RCA-78-23-005-1: Reroute Cowl Harness

Document Type	Customer Satisfaction Campaign Bulletin
Date	August 9, 2023
Affected Region(s)	USA, Canada
Affected Model(s)	R1T, R1S
Model Year(s)	2023
Approximate Build Dates	February 2023 - March 2023
 Refer to Open Containments in ServiceOS to determine if this document applies to a specific vehicle.	
Vehicle System	78 - Low Voltage Electrical
Minimum Service Location	Service Center

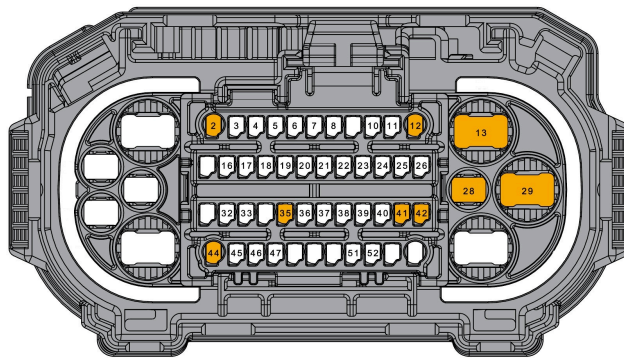
1. Remove: Screen, Leaf (refer to service manual procedure 647920010).
2. Inspect the wires in the highlighted area:

- If abrasion has damaged the wiring insulation:
 - If any of the following wires are affected: Replace: Harness, Cowl (refer to service manual procedure 787054010). Continue to the next step.

- Repair any other damaged wires. Escalate for diagnostic assistance. Continue to the next step.
- If the protective tape has abraded and exposed wiring insulation, but the wiring insulation is not damaged: Rewrap the affected area with new protective tape. Continue to the next step.
- If the wiring and tape are undamaged: Continue to the next step.

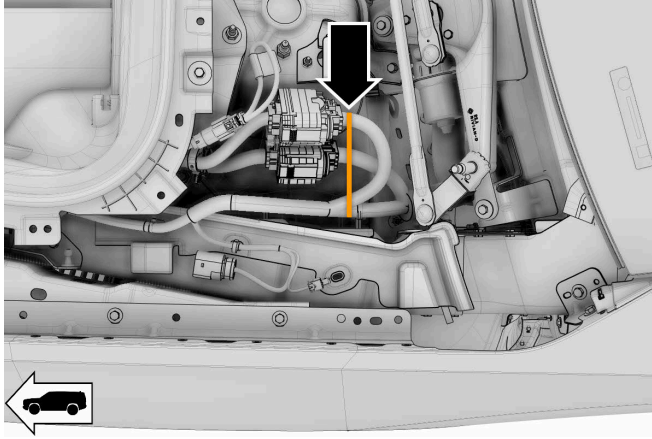
3. Install: Cable tie. Position the component(s) as shown.

Note: Shown with components removed for clarity.

Note: If necessary to fully secure the component: Install additional cable ties.
